Product Advisory

Product Family:	ASO Safety Mats with Tapered Edge	Number:	PA-SPE-005
Part Numbers:	1602-4xxx	Date Issued:	06/18/21
Subject:	Change in ramp dimension for safety contact mats with tapered edge.	Revision:	Original

1602-4093

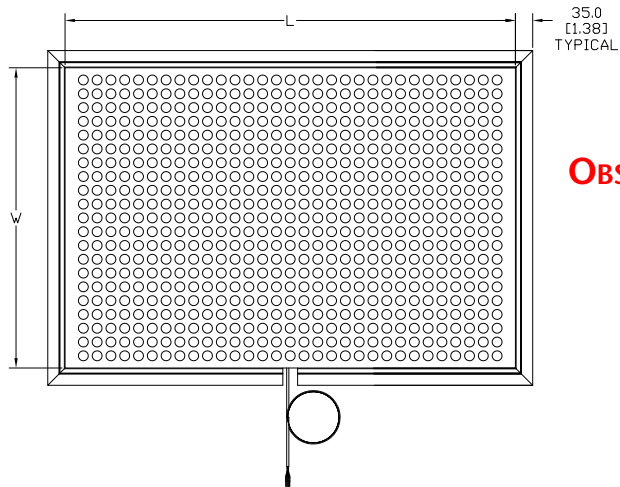
The dimension of the tapered edge of the ASO Safety Mats are changing from 35mm to 30mm. Since the nominal dimension of the mat usually corresponds to the sensor area, this change has no effect on the order size.

OBSELETE!

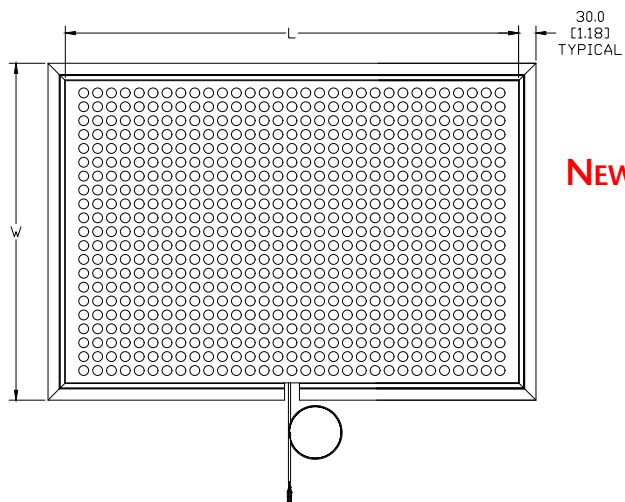
NEW!
